ADDENDUM #4

Essexville-Hampton Public Schools
New Innovation Center Project
September 14, 2026

Project: EHPS New Innovation Center Project

RE: Pre-Bid RFI Response

Drawing
SITE PLAN SHEET

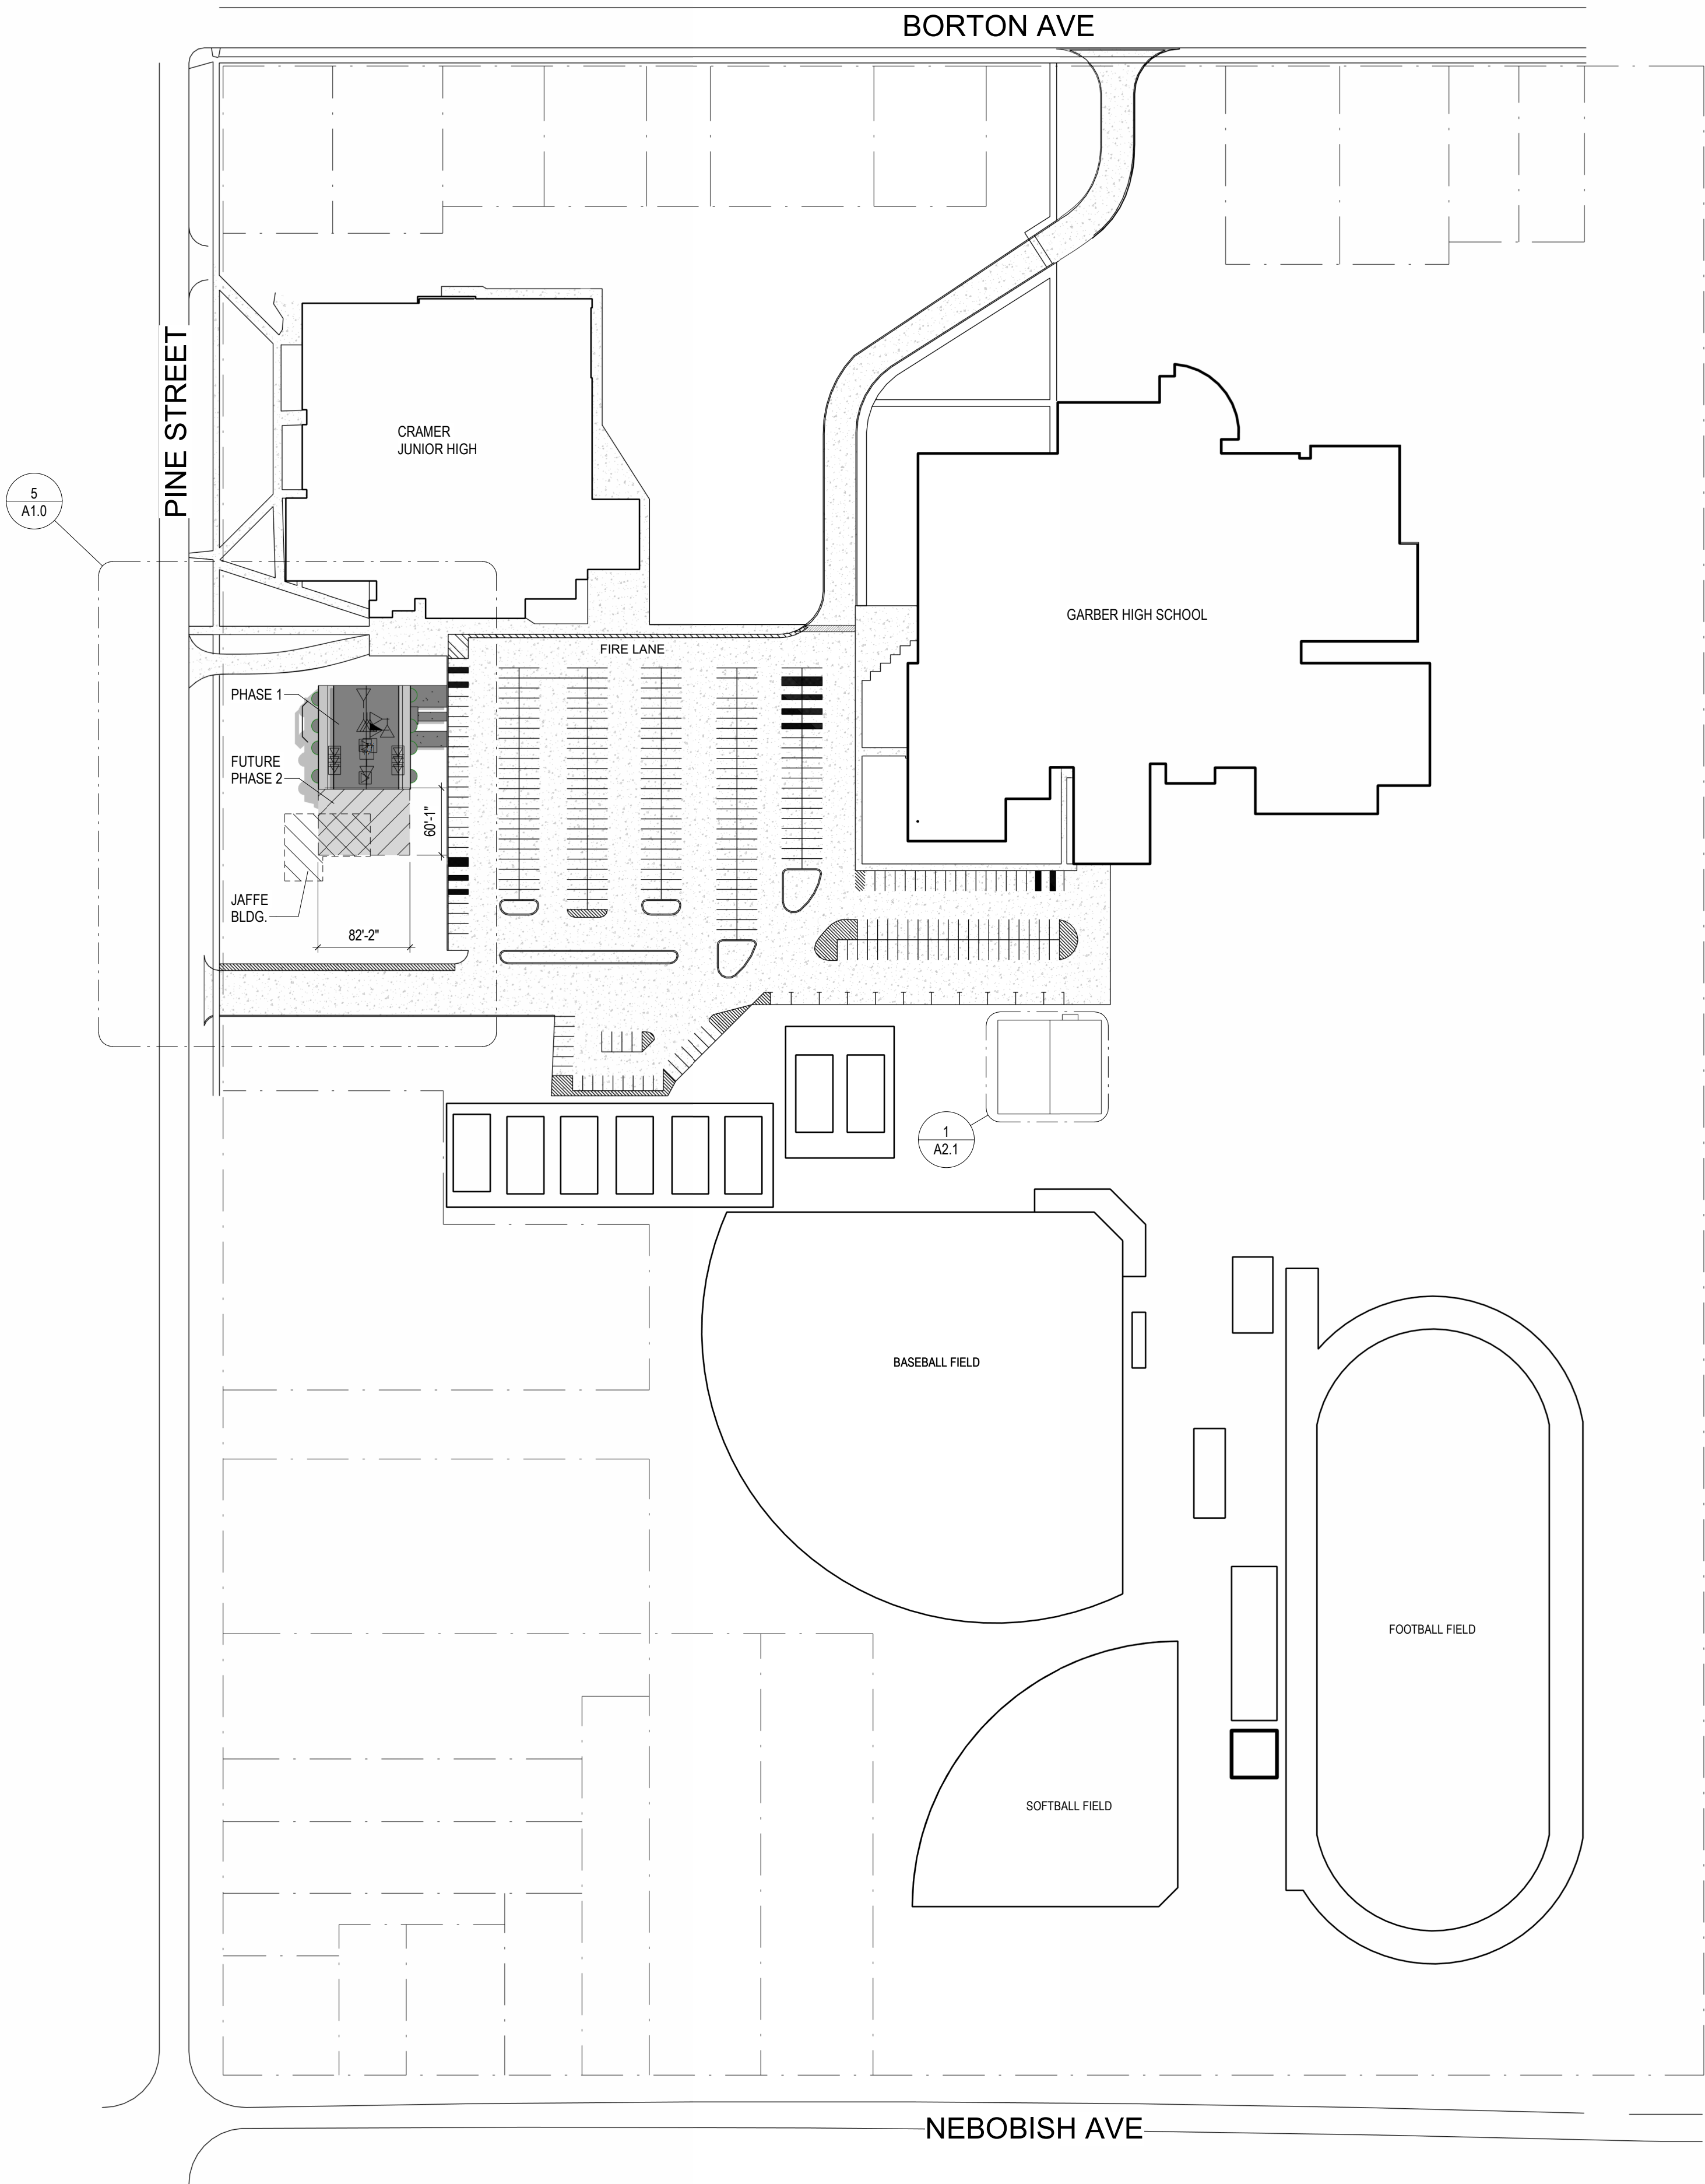
1. We are reviewing the landscaping scope for the Essexville-Hampton New Innovation Center project. The drawings show landscaping beds and low-lying shrubbery, but we could not locate a plant schedule identifying the required species, sizes, quantities, or spacing. Could you please provide the planting requirements or clarify what bidders should carry in their proposals?
 - a. See attached re-issued C5.0 - Site Plan Sheet.

1 First Floor Plan

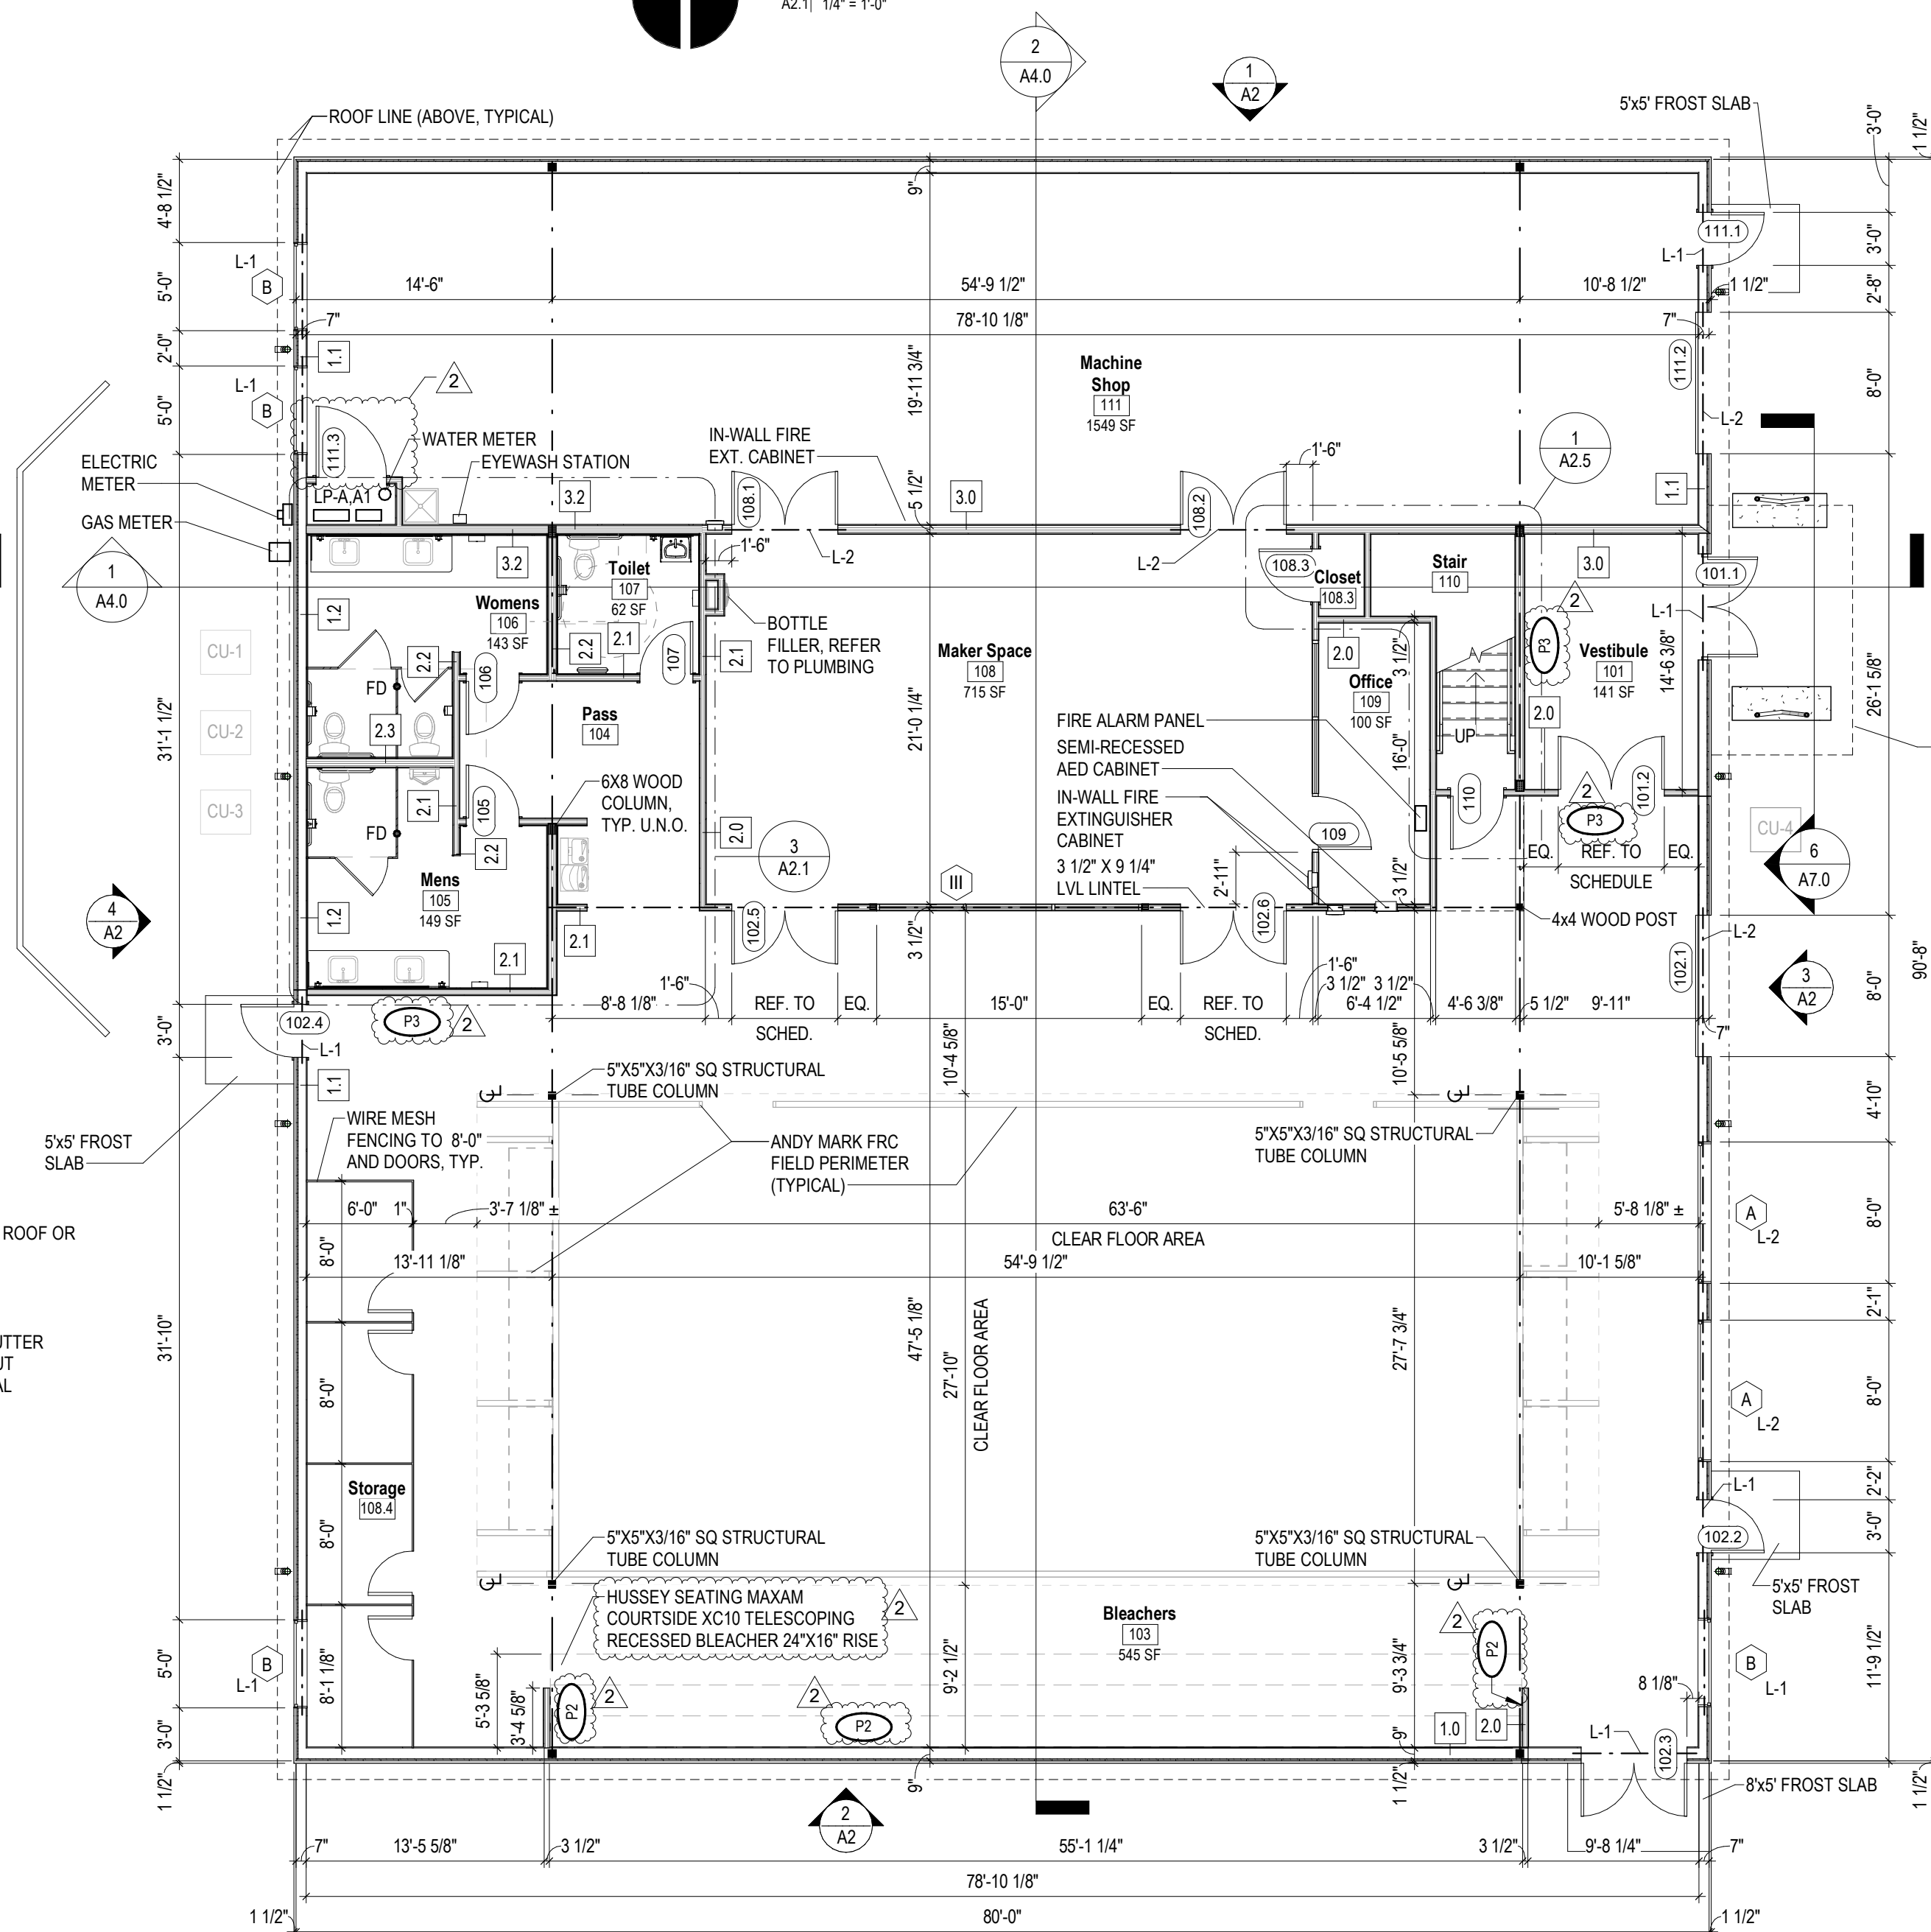
1. Page E1.0 panels LP-A & LP-a1 - these are in room 111 (noted as hazardous location). Will these two panels be relocated to a different room or enclosed in a separate room? I'm not sure that any manufacturer can provide these panels to meet this requirement.

- a. A wall and door has been added in front of the electrical panel. Please see re-issued 1/A2.1.
2. Is the Crouse Hinds disconnect required to be suitable for hazardous locations as indicated by the part number provided? It's located in room 108 (outside of room 111 - classified hazardous location).

A2.1 - First Floor Plan, Second Floor Plan and Enlarged Plans - Re-Issued

- a. Updated to include new wall and door at electrical panel in Machine Shop 111.
